REMARKS

## SELF-DRAINING BOAT WINDOW

*Fig.5   Fig.6   Fig.7*

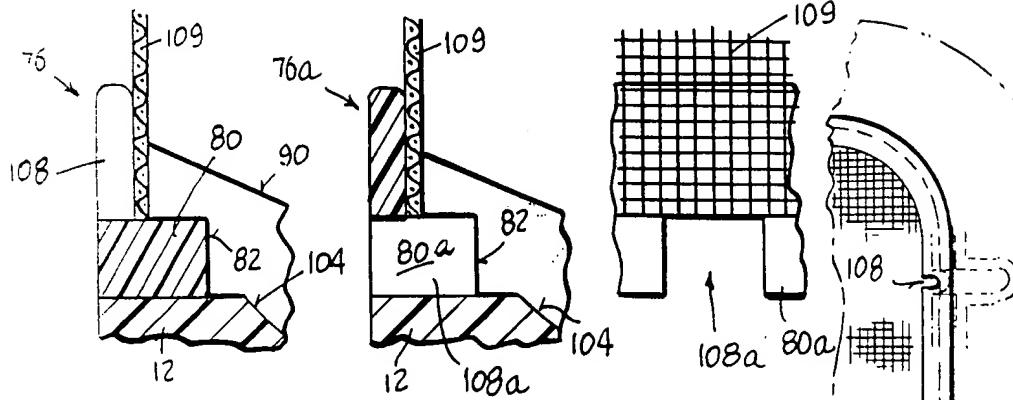
With respect to claim 8, in the specification, page 9 lines 14-19 state that the groove 82 communicates with the wall 104 of the groove 98 so as to provide for drainage of water from the groove 82. It is believed that the recitations are correct. In support of this, one can determine from Fig. 5, that if the screen (flange 80) were removed, the area indicated 82 would be space, as would the area indicated 104. These spaces would overlap, that is, there would be communication between them in order to permit water to flow from the space 82 into the groove (wall 104). If it is still believed that the present disclosure is not correct, an opportunity to discuss the matter with the Examiner would be appreciated.

*Fig. 4*

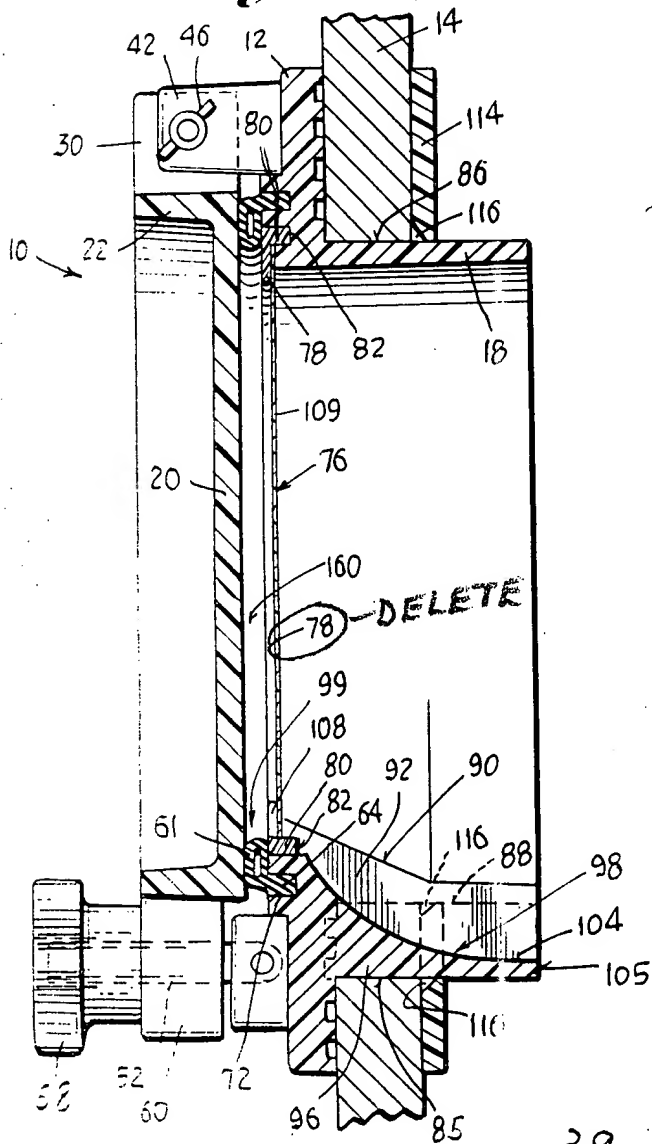
In a separate letter to the Official Draftsman, directions for correction of the drawings, Fig. 4, are given. These changes are in accordance with the recommendations of the Examiner as set forth in the second paragraph of the Official Action.

The specification has been amended on page 8, line 15 in order to clarify the terminology. As now recited, the screen has a peripheral frame 78 which can be considered to be the portion of the screen that is of relatively flat, rectangular configuration, and a flange 80 which is integral with the frame, and is the part which fits into the groove 82, this part being of generally square cross section in Fig. 4.
